# A96 Threapland Junction Improvements Environmental Statement Addendum

January 2009

#### **Environmental Statement Addendum**

Replace Figure 6.3 (Landscape Design) with that which follows.

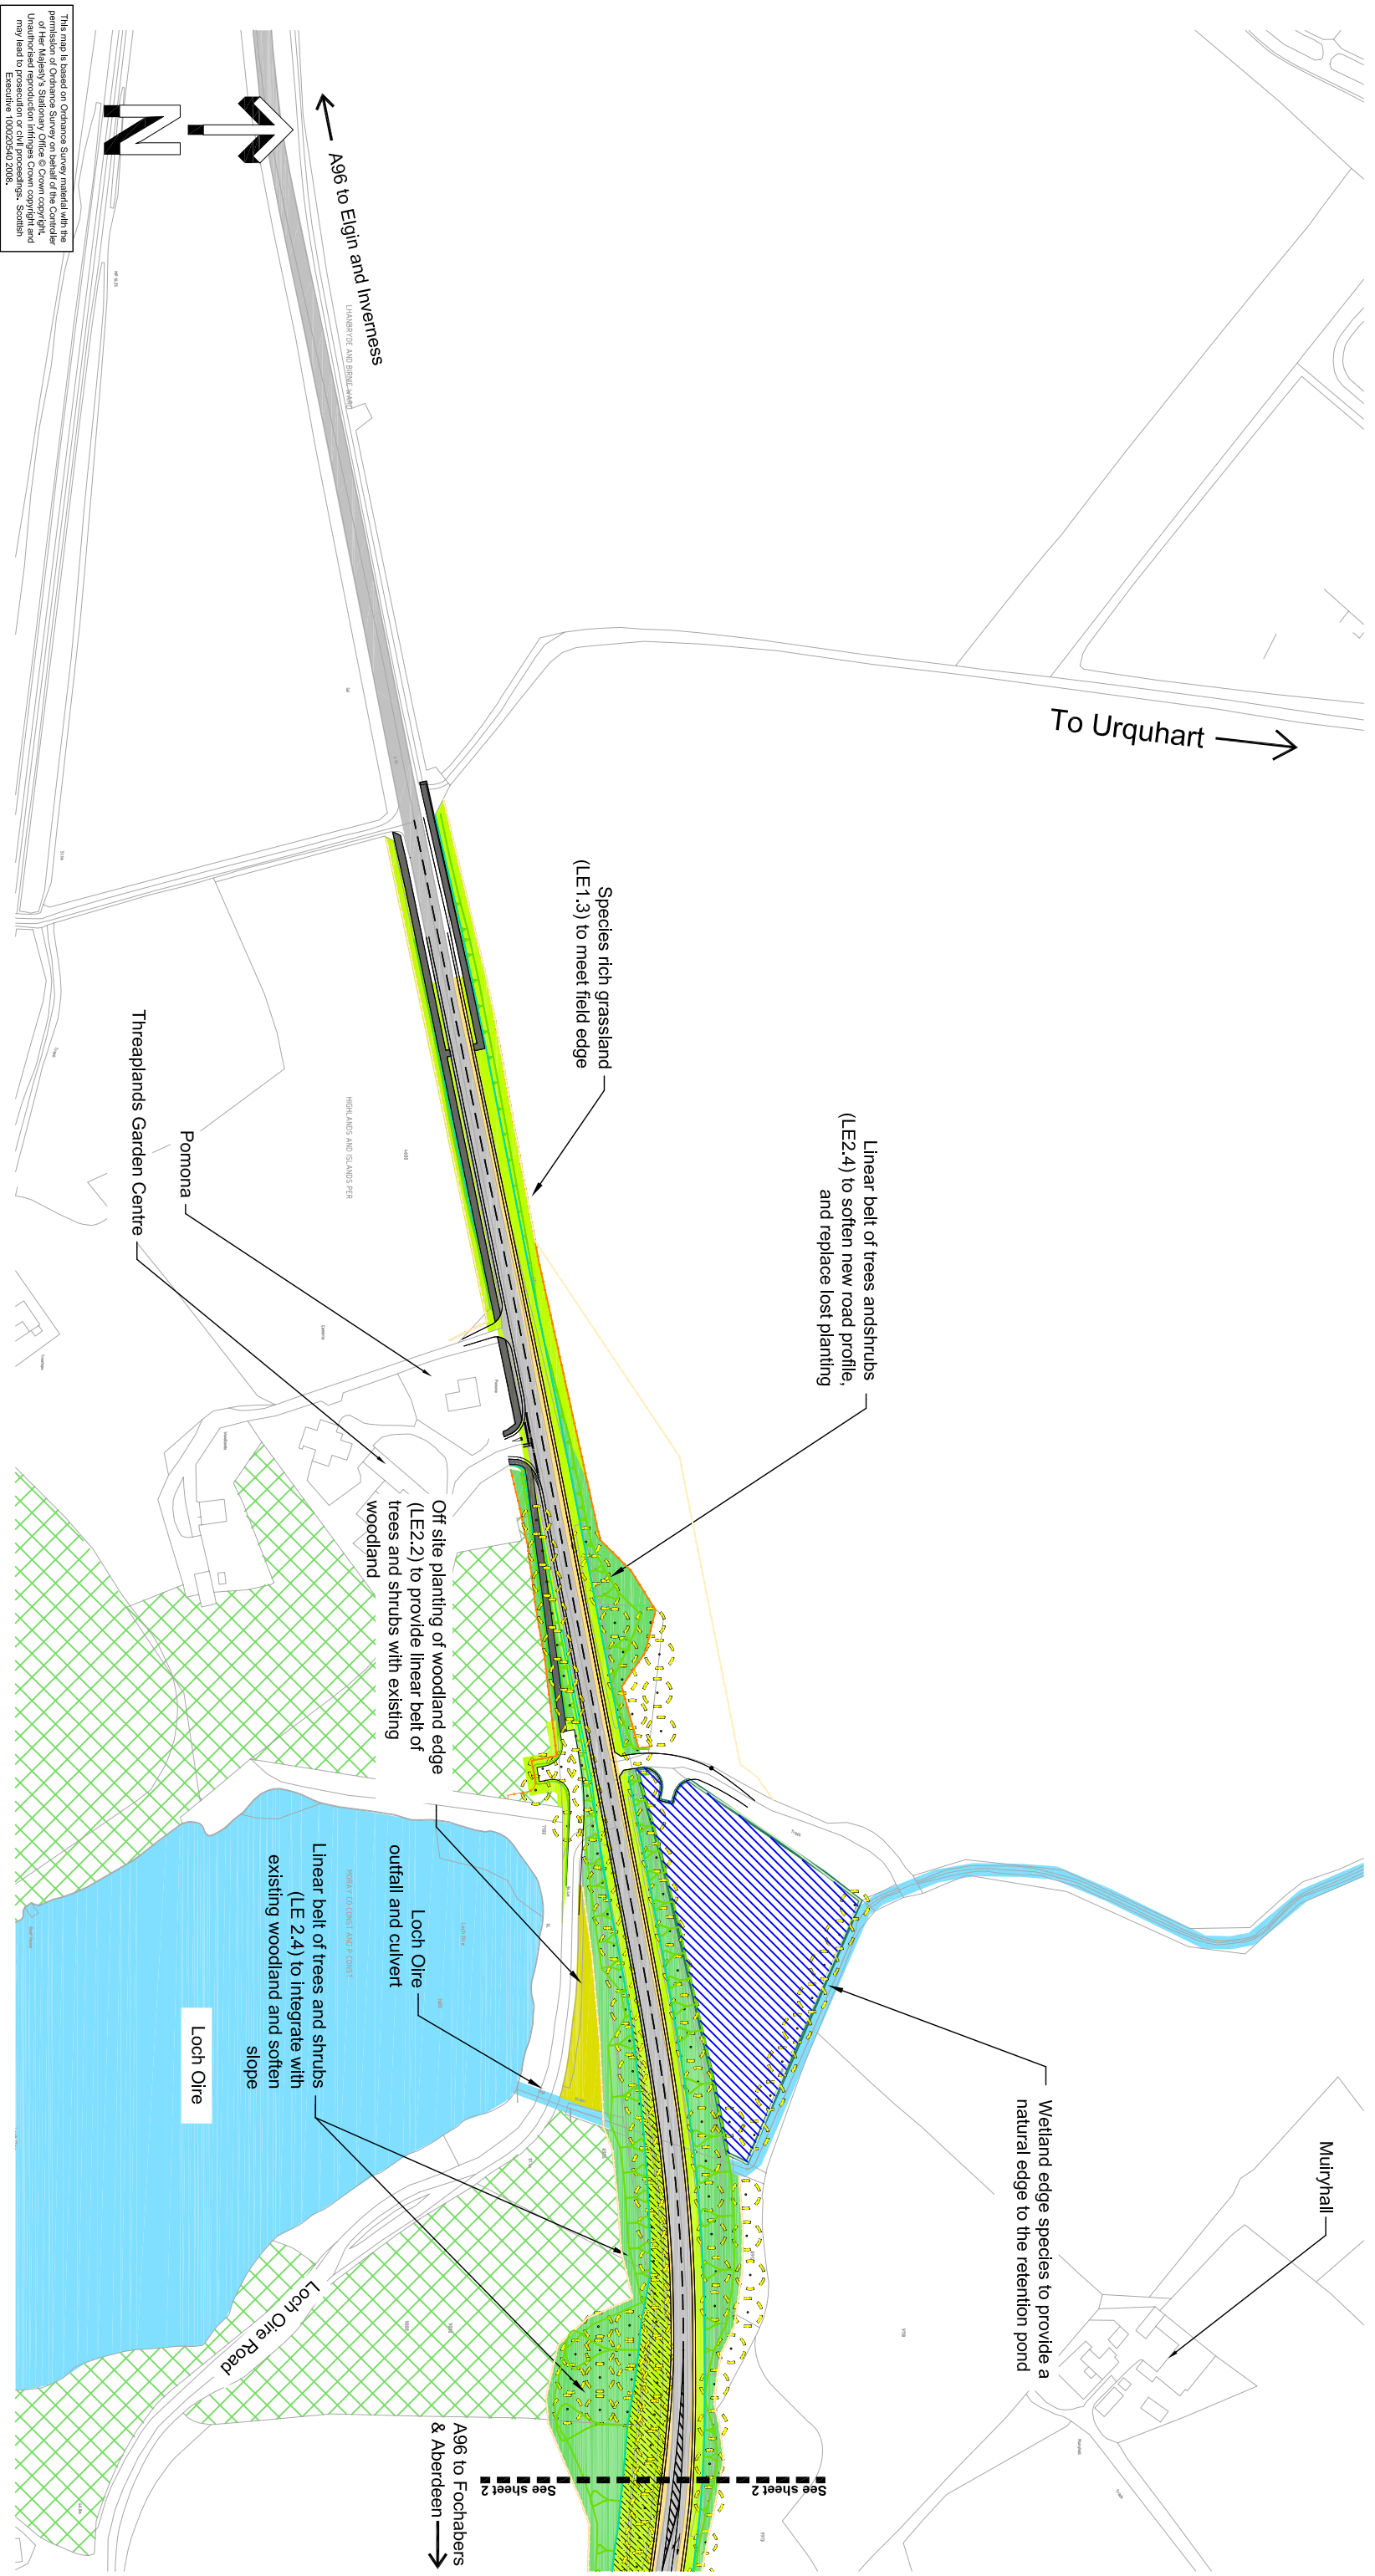
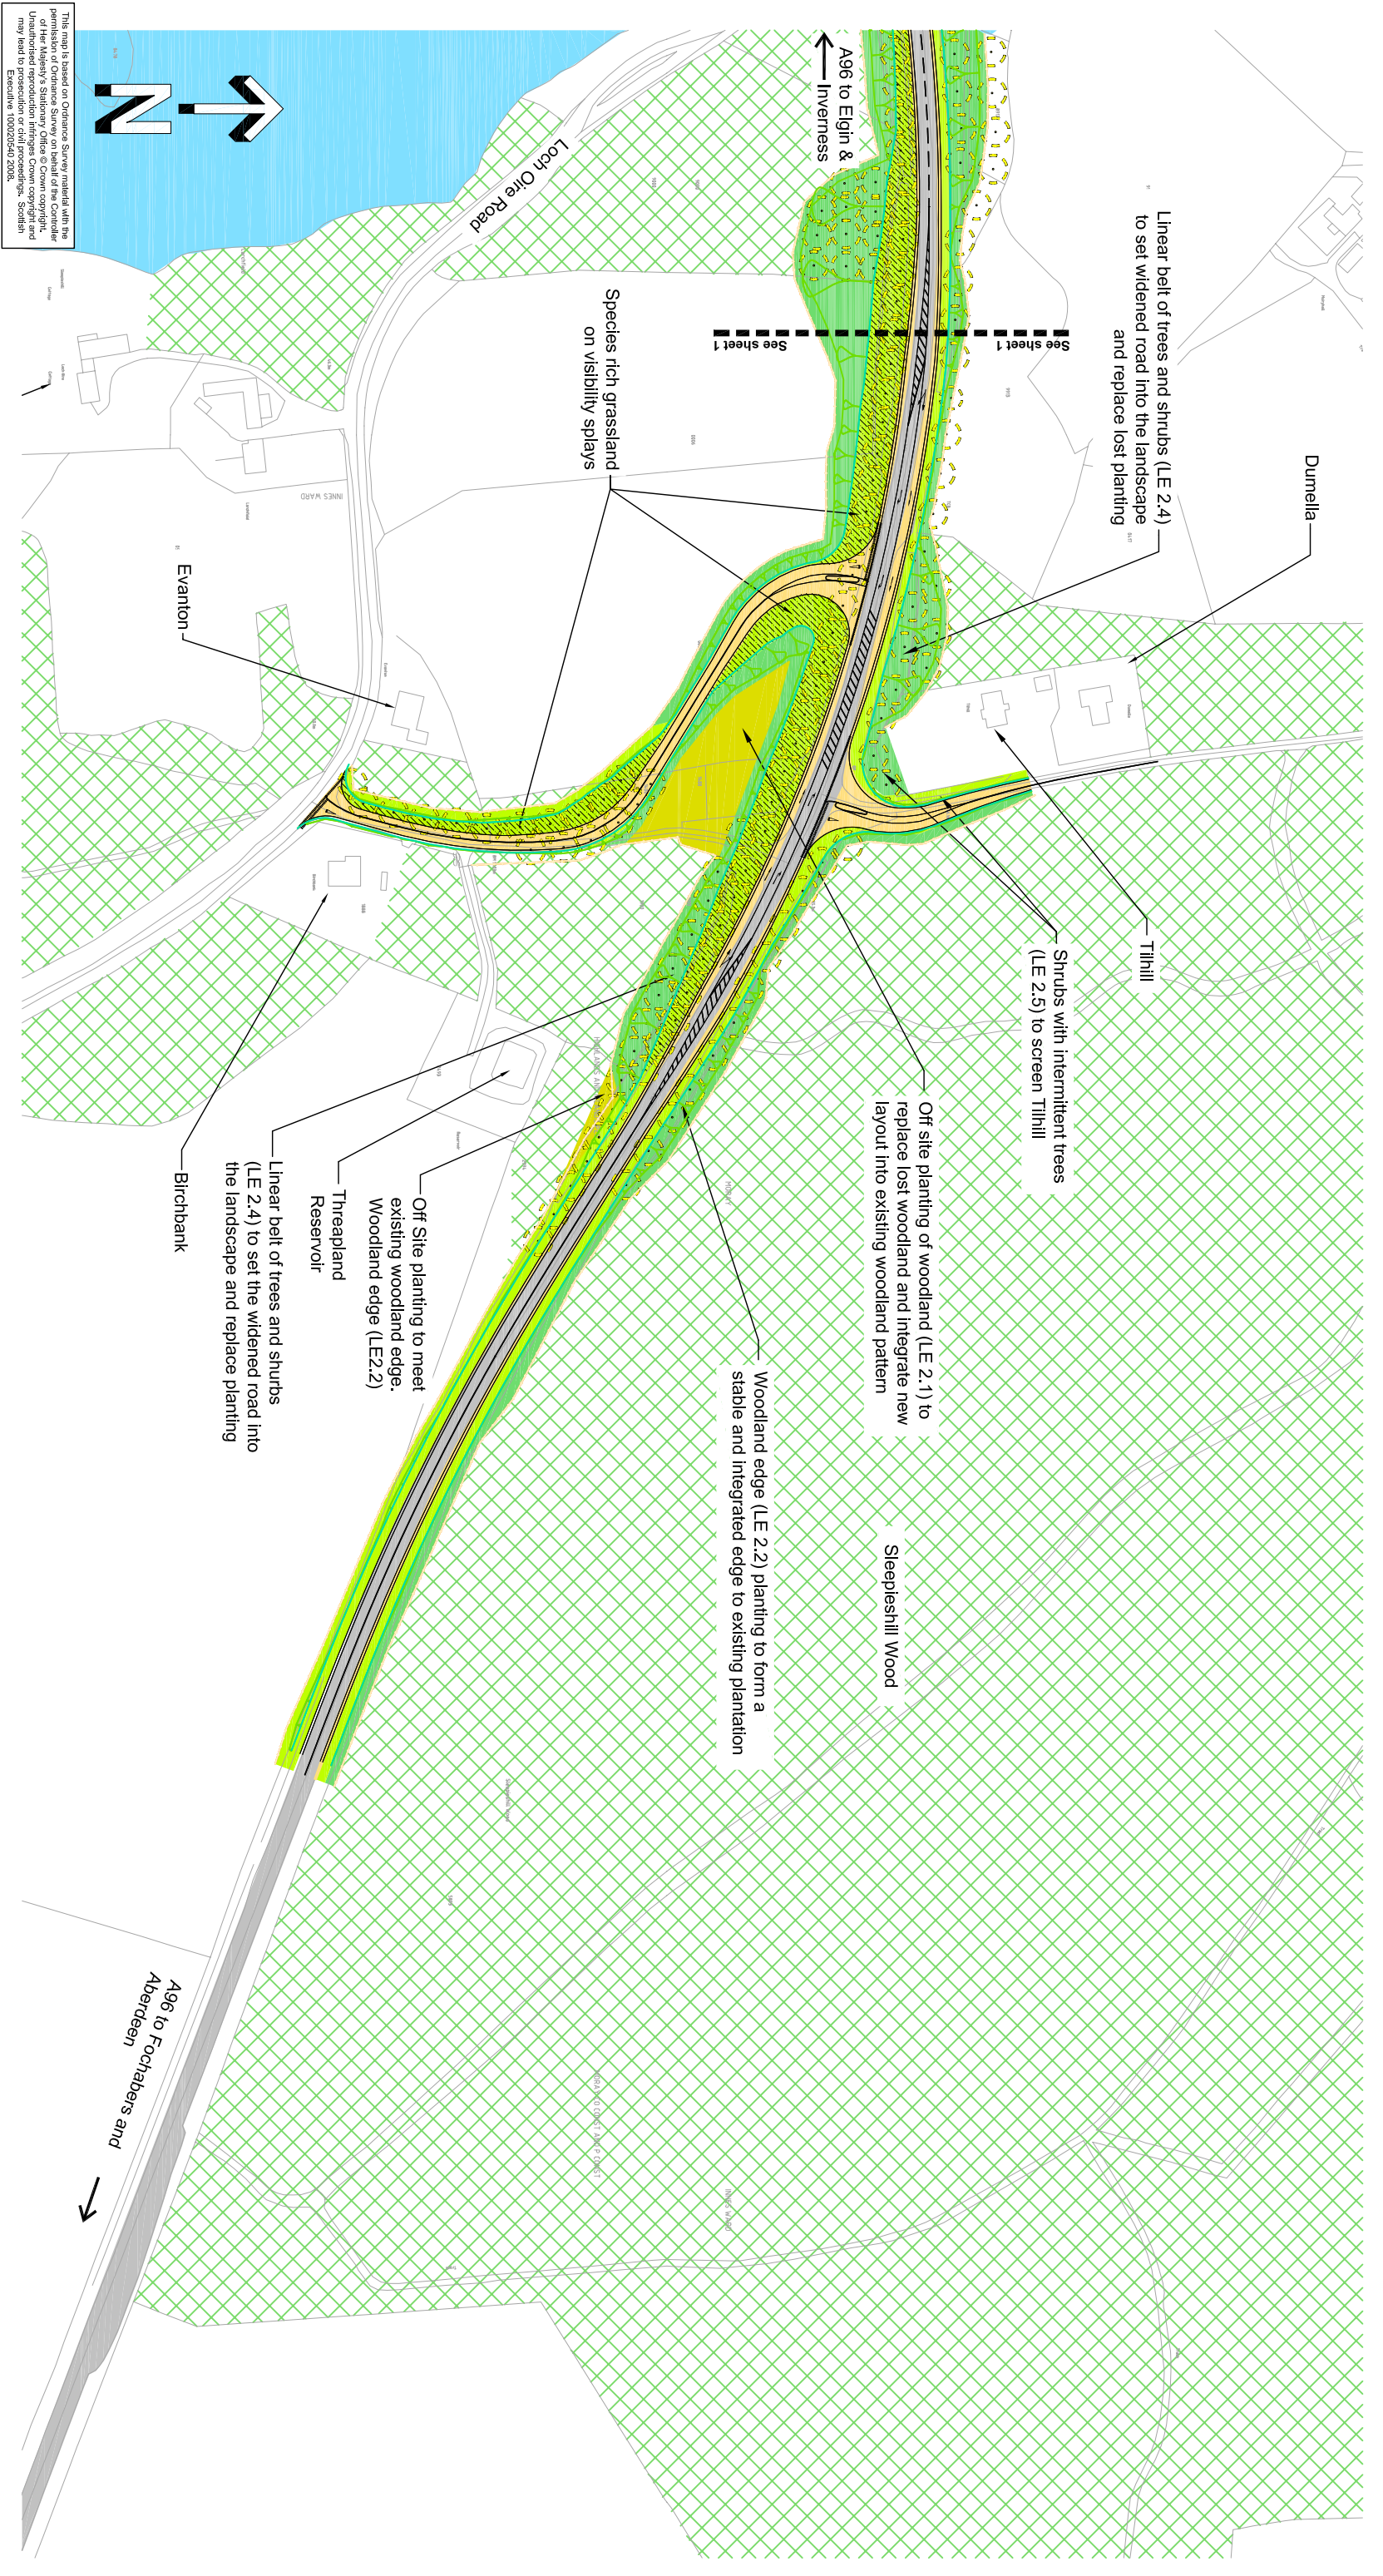
**Chapter 6: Landscape and Visual** – No changes required. Original text is still relevant and is reported in Chapter 6 of the A96 Threapland Junction Improvements Environmental Statement, October 2008. Figure 6.3 has been updated to reflect the new position of the Loch Oire Road vehicle turning area and to eliminate tree removal from within the grounds of the property at Tilhill. These amendments are included in Appendix E of this Addendum.

FIGURE 7.1

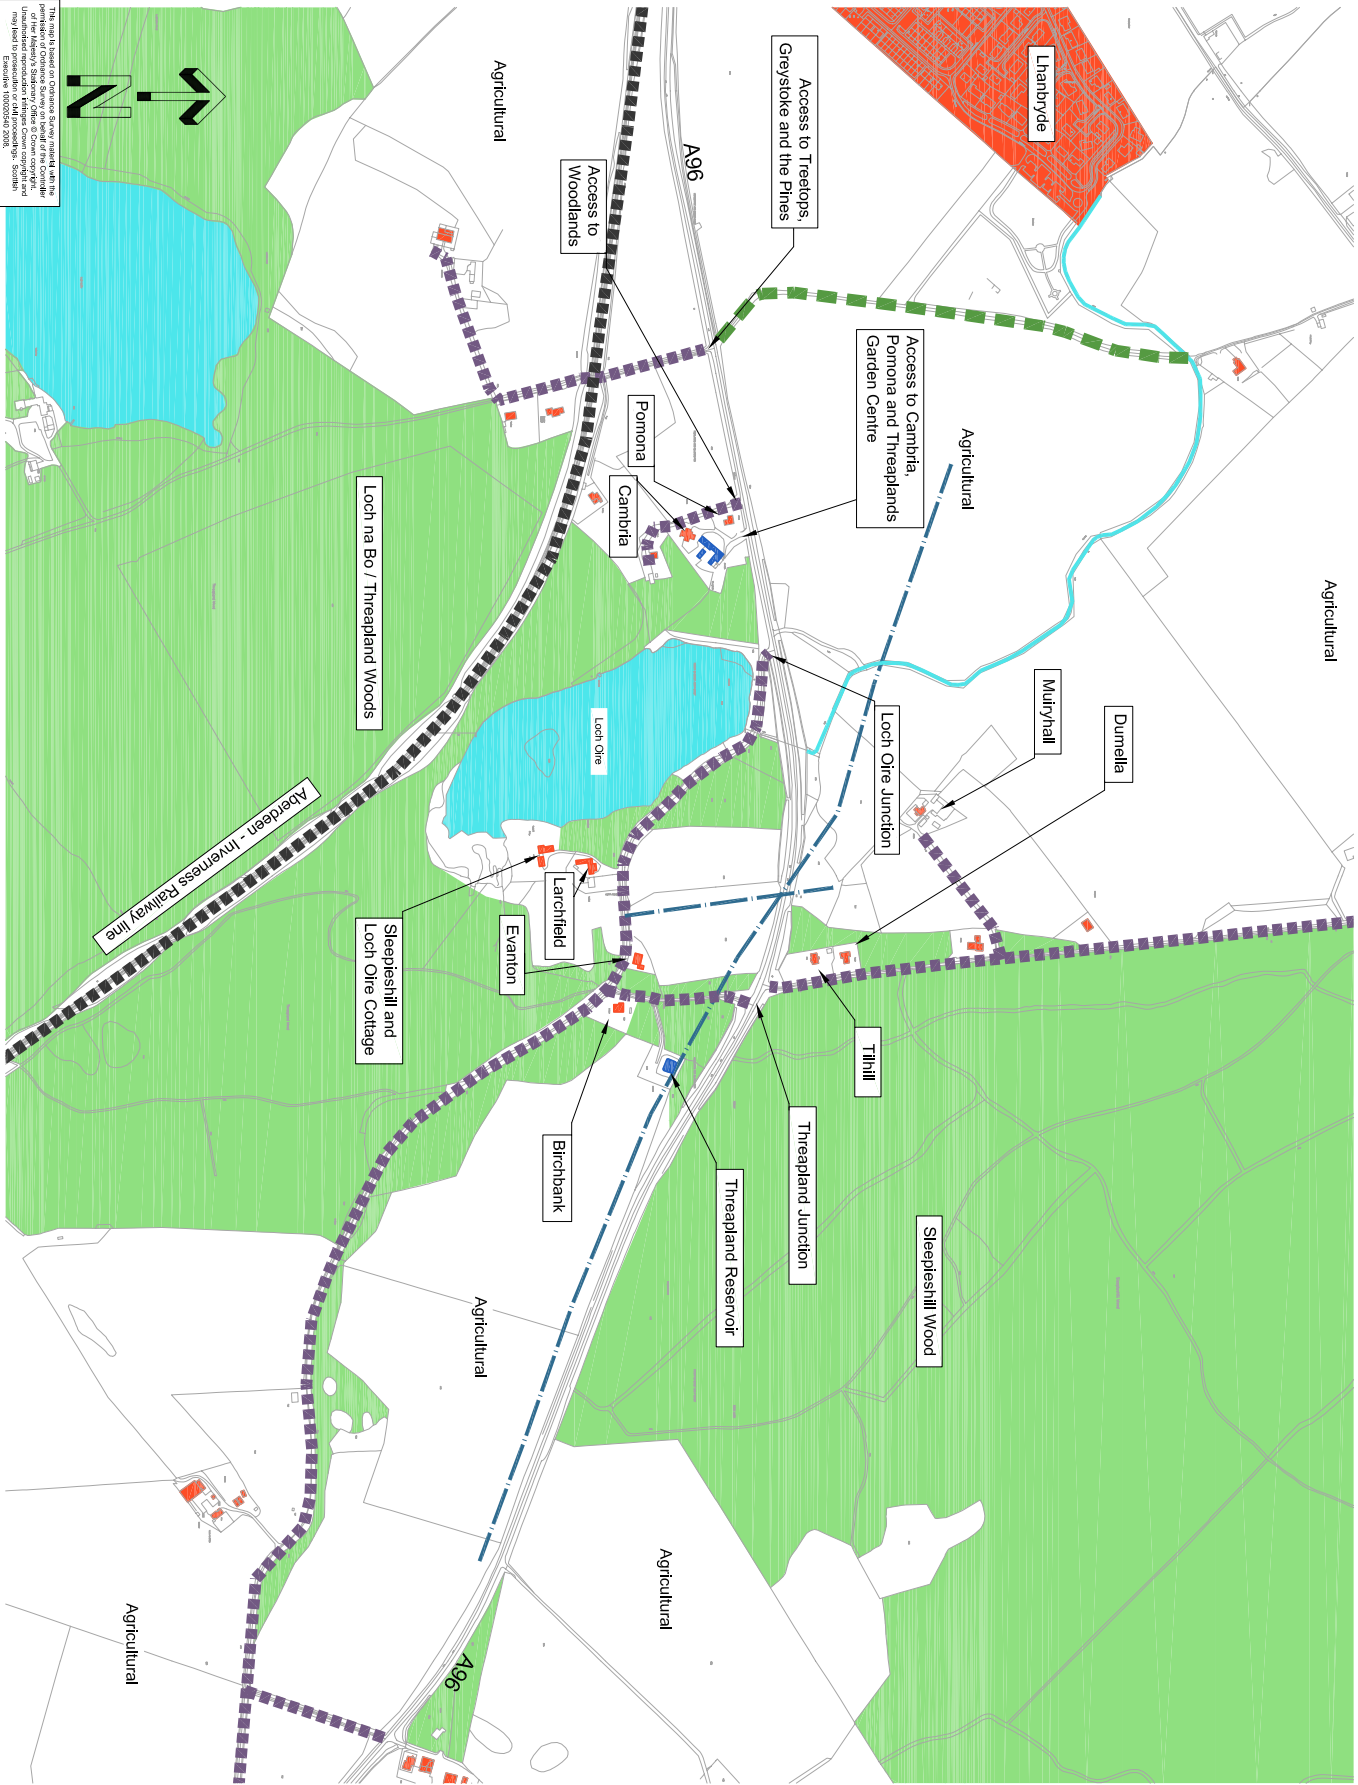
**Chapter 7: Land Use** – The new location and layout of the Loch Oire Road vehicle turning area involves a reduction in landtake as it is now situated outwith the SSSI. The text of Chapter 7 has been updated to reflect these changes and also to include Cambria, Sleepieshill and Loch Oire Cottage as residential properties in close proximity to the Scheme and to identify Cambria as a main receptor. Figure 7.1 has been updated to show Cambria as a residential receptor. These amendments are included in Appendix F of this Addendum.

Replace Figure 7.1 (Land Use) with that which follows:
